Airworthiness Directives; Cessna Aircraft Company Models 150, 152, 170, 172, 175, 177, 180, 182, 185, 188, 190, 195, 206, 207, 210, T303, 336, and 337 Airplanes

ACTION: Final rule.

2011-10-09 Cessna Aircraft Company:
Amendment 39-16690; Docket No. FAA-2010-1101; Directorate Identifier 2009-CE-013-AD.

Figure 1. Diameter of seat pin locking engagement hole

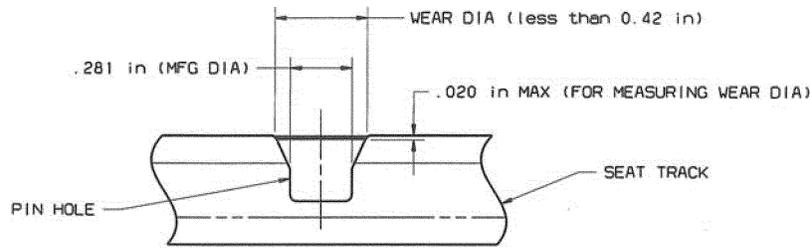
Dave McFarlane requested we add a maximum allowable incremental 0.07-inch radius dimension to figure 1 at the outside diameter dimensions for clarification.

We disagree with this comment. The measurement dimensions in figure 1 adequately address the measurements necessary for this AD. Additional measurements will not provide any additional benefit.

Figure 4. Closeup of seat roller housing and tang gap width

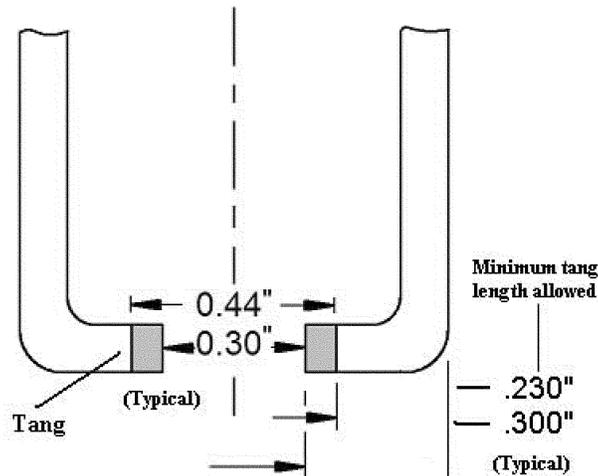
Brian A. Andrus, Jim Currie, and Jerry Unruh requested we change the tang measurement to the outside of the seat roller housing and change the description of the tang measurement. This change would make it easier for the inspector to take the measurement and to better understand what is being measured.

We agree with this comment. We agree that measuring the tang length inside of the roller housing is difficult because of the presence of the rollers inside of the roller housing.

We have changed the callouts in figure 4 to measure the tang length from outside of the roller housing instead of from inside of the roller housing. We have also changed the description of the tang measurement in figure 4 to more accurately describe the measurement.
